HISTORIC AND DESIGN REVIEW COMMISSION

October 17, 2018

HDRC CASE NO: 2018-514
ADDRESS: 400 EAGLELAND DR
LEGAL DESCRIPTION: NCB 3018 BLK 3 LOT 13 EXC NW IRR 124.73FT BRACKENRIDGE
HIGH SCHOOL SUB
ZONING: RM-4
CITY COUNCIL DIST.: 5
APPLICANT: Suresh Modadugu/Stantec
OWNER: San Antonio ISD
TYPE OF WORK: Exterior modifications, construction of multiple additions, site
modifications, signage
APPLICATION RECEIVED: September 28, 2018
60-DAY REVIEW: November 27, 2018
REQUEST:

HDRC Booklet
October 17, 2018

SCHEMATIC MARQUEE SIGN

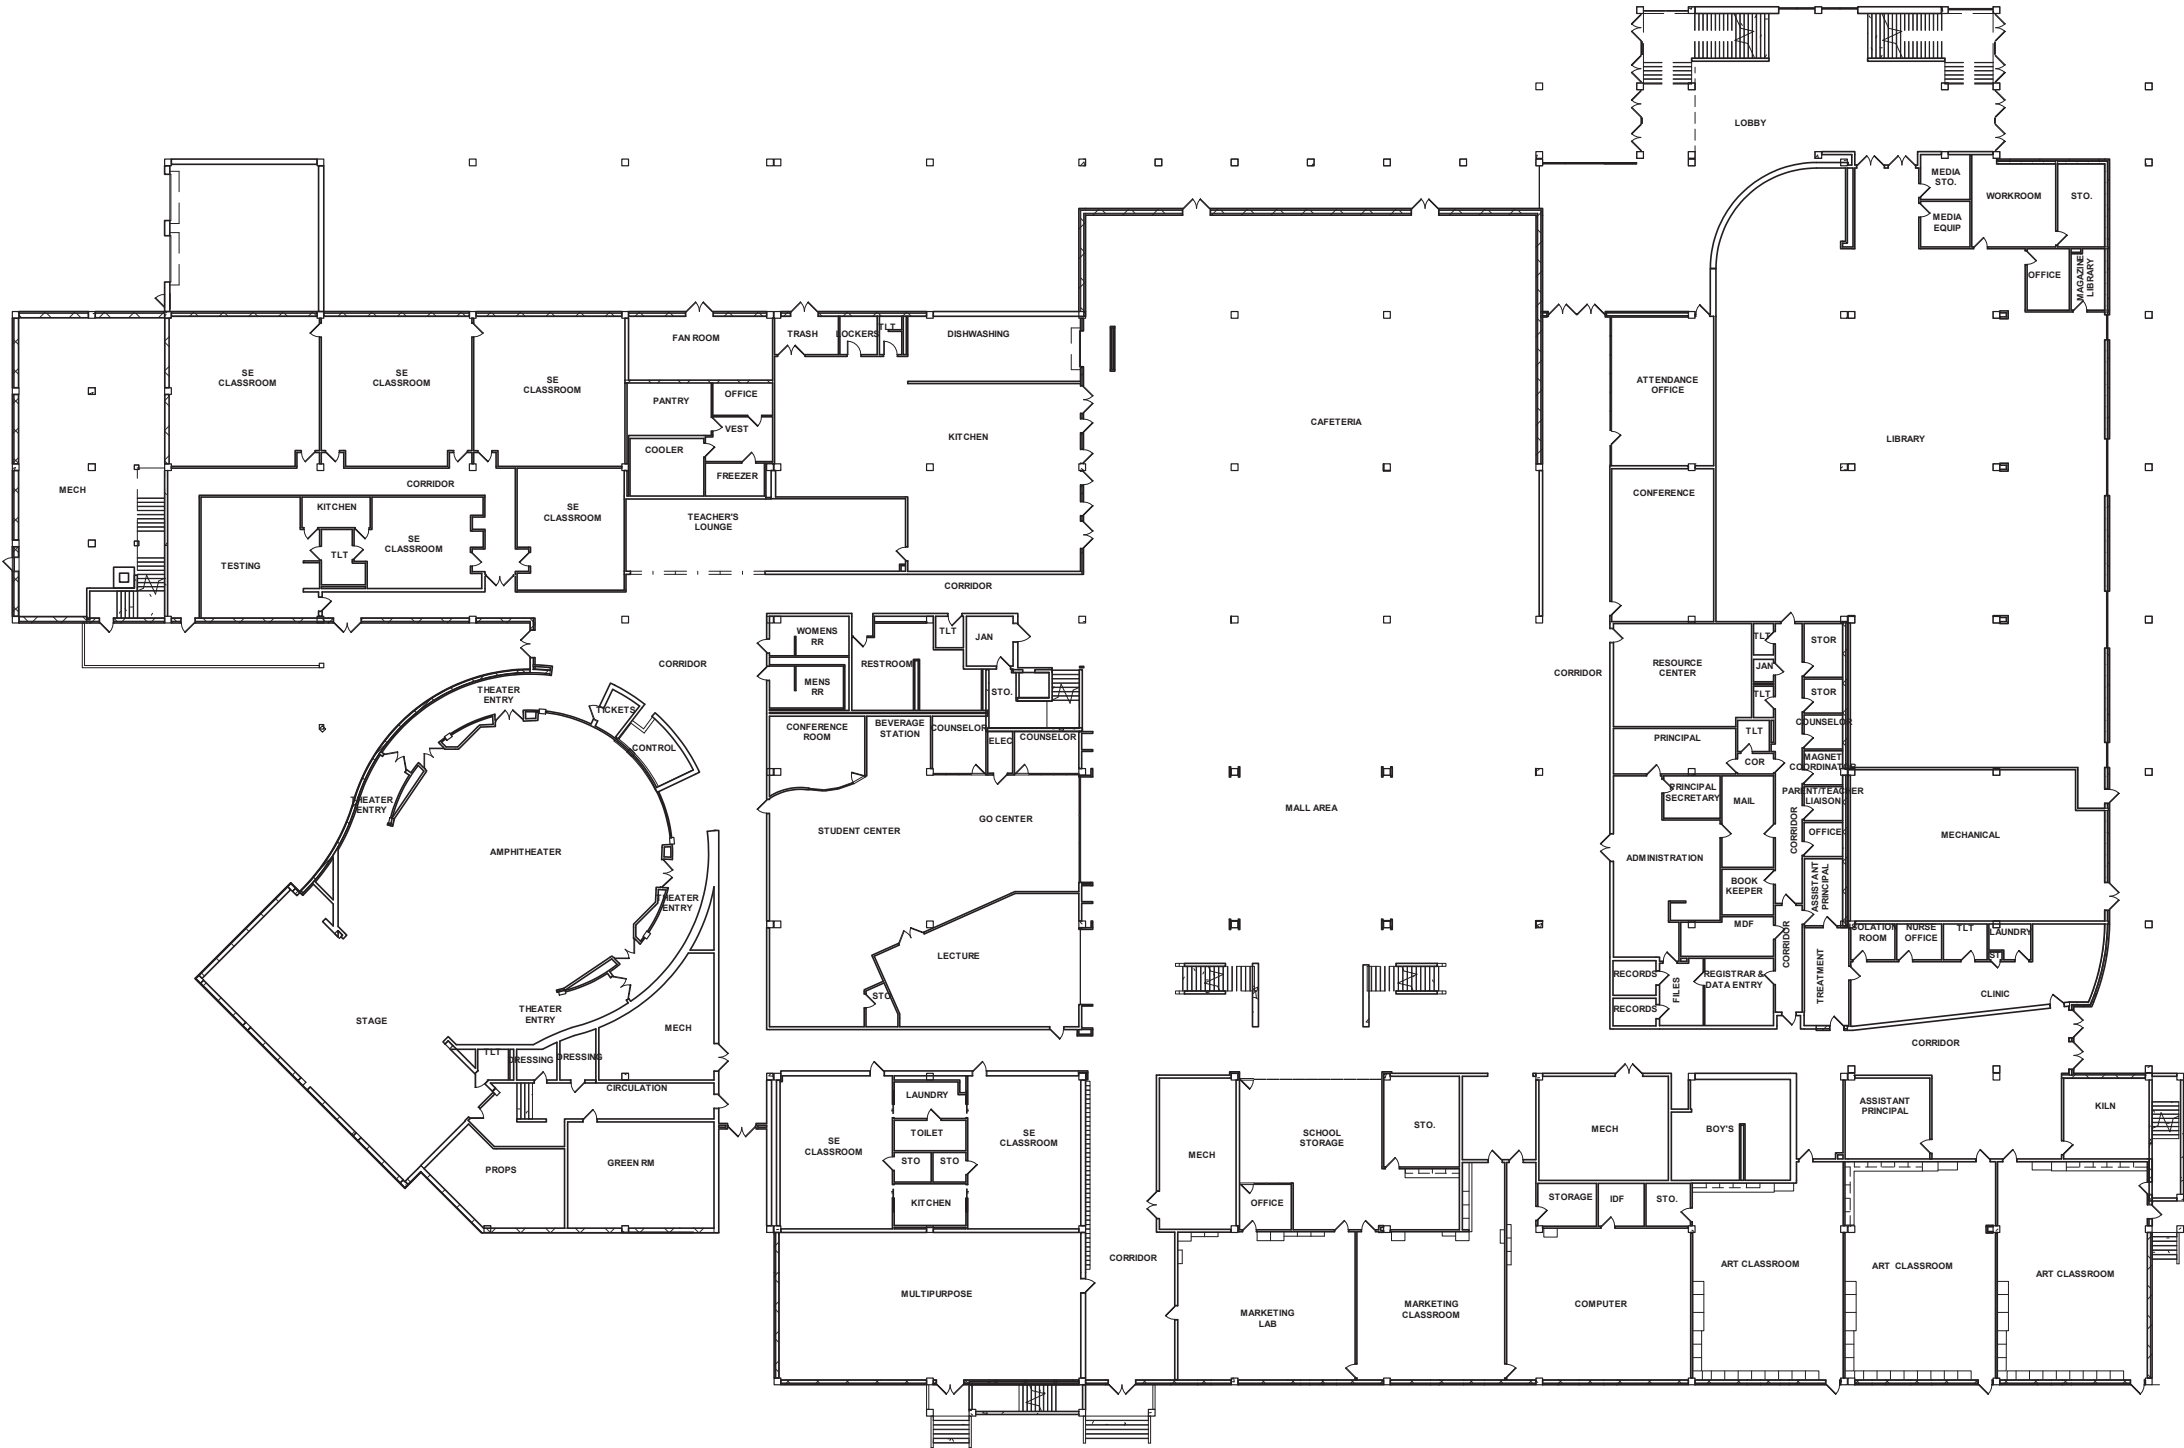
- d. SIGNAGE – Based on the submitted documents and renderings, the applicant is considering proposing a new freestanding monument sign with a digital marquee at the intersection of Eagleland Dr and S St Mary's. The sign is proposed to be 20'-9" in height with a masonry base and monument and a horizontally-oriented digital marquee sign. According to UDC Section 35-867, freestanding signs should be limited to six feet. Staff finds that the height of the sign should be significantly reduced to be consistent with RIO sign standards and the surrounding context of the neighborhood, which is primarily residential. Any proposed freestanding or monument sign should be oriented towards pedestrian and slow-moving traffic.

- i. That the applicant reduces the height of the proposed freestanding monument sign as noted in finding d.
- ii. ARCHAEOLOGY- The project shall comply with all federal, state, and local laws, rules, and regulations regarding archaeology.
